RCRA CORRECTIVE ACTION PERMIT

UNION CARBIDE CORPORATION

Permit ID # WVD060682291

FINAL DECISION AND RESPONSE TO COMMENTS
UNION CARBIDE CORPORATION
TECHNOLOGY PARK

Figure 2
 Proposed Future Land Use
 Statement of Basis
 UCC Technology Park
 South Charleston, West Virginia

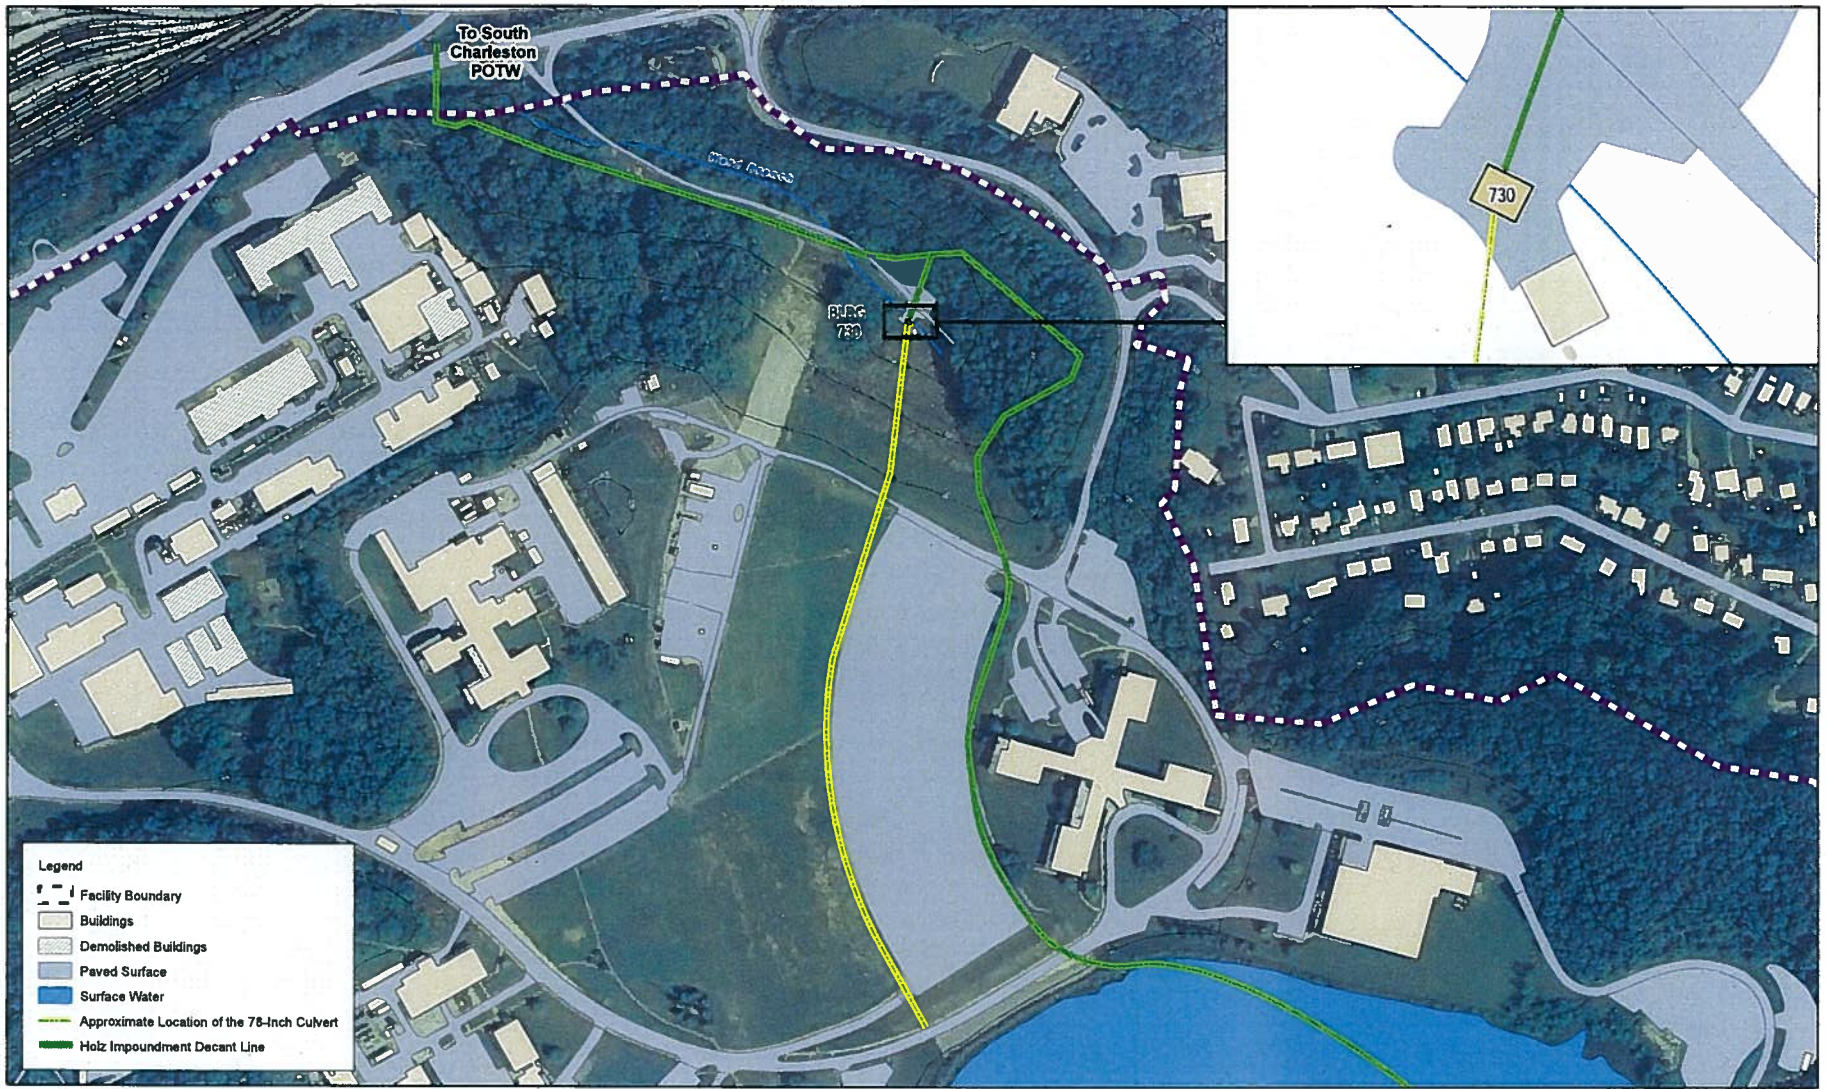
Figure 2 does not show the area that was sold to the United Disciples of Christ Church. UCC proposes including an updated version of Figure 2 (attached) in the Statement of Basis and the Final Decision Document. The updated figure shows the area of Tract D that was sold in July 2010. In addition, UCC proposes that paragraph 6 be revised to state, “In addition, in July 2010, a portion of Tract D (shown as “Area D-1” on Figure 2) was sold by UCC...”

EPA agrees with the comment and has incorporated this change into the Final Decision by including a revised Figure 2.

Figure 5
Restrictions
Statement of Basis
UCC Technology Park
South Charleston, West Virginia

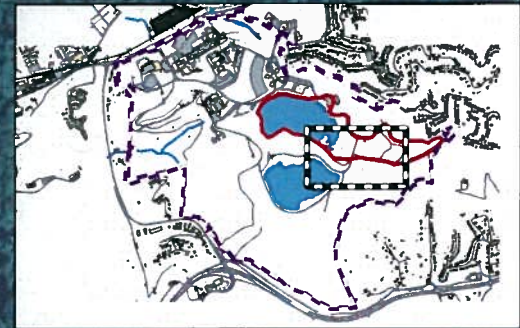
Figure 5 of the Statement of Basis does not show all of the areas where UCC proposed subsurface work restrictions. UCC proposes including an updated version of Figure 5 (attached) in the Statement of Basis and Final Decision Document. The updated figure shows all of the areas where UCC proposed subsurface work restrictions.

EPA agrees with the comment and has incorporated this change into the Final Decision by including an updated Figure 5.
